Marine and Environmental Affairs

ADA Transition Plan

October 2021

Institute for Human Centered Design

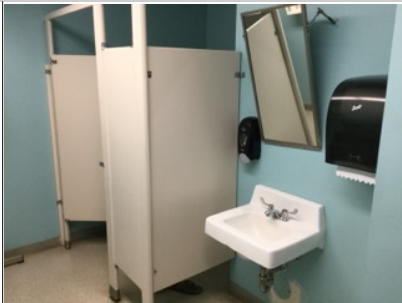
7	Reception to Toilet Rooms	1		Interior Access Route	N/A		Route < 36" wide	28.75"	Ensure that a clear width of 36" min. is maintained at the accessible route.	1	Labor	\$0
8	Men's Toilet Room	1		Interior Access Route	N/A		Route < 36" wide Obstructed by protruding objects	24" 12"	Remove furniture to ensure that a clear width of 36" min. is maintained at the accessible route.	1	Labor	\$0

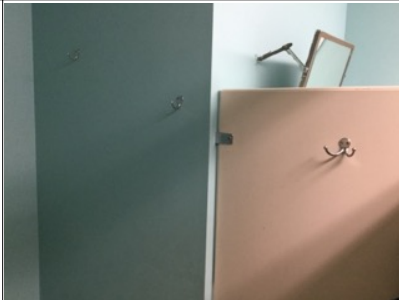
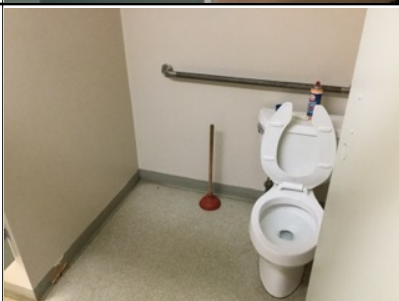
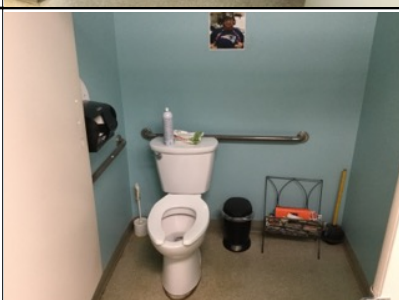
ID	Location	Floor	Room	Element	Type	Photo	Issues	Current Measure	Recommendations	Quantity	Price	Cost Estimation
9	Corridor to Toilet Rooms	1		Interior Access Route	N/A		Obstructed by protruding objects	7"	Provide a cane-detectable barrier.	1	306	\$306
10	Service Counters	1		Interior Access Route	N/A		Obstructed by protruding objects	5.25"	Provide a cane-detectable barrier.	1	306	\$306
Doors, Doorways, & Gates												
11	Women's Toilet Room	1		Doors, Doorways, & Gates	Toilet Room		Maneuvering clearance(s) not provided	16.5"	Install an automatic door opener.	1	3060	\$3060
12	Men's Toilet Room	1		Doors, Doorways, & Gates	Toilet Room		Maneuvering clearance not provided at recess > 6"	10"	Install an automatic door opener.	1	3060	\$3060
13	Women's Toilet Room	1		Doors, Doorways, & Gates	Toilet Room		Hardware not operable with a closed fist No visible fire alarm provided within room	-	Provide hardware that can be operable with one hand and not require tight grasping, pinching, or twisting of the wrist. When fire system is updated, ensure that a visible fire alarm is installed in each room.	1	484	\$484
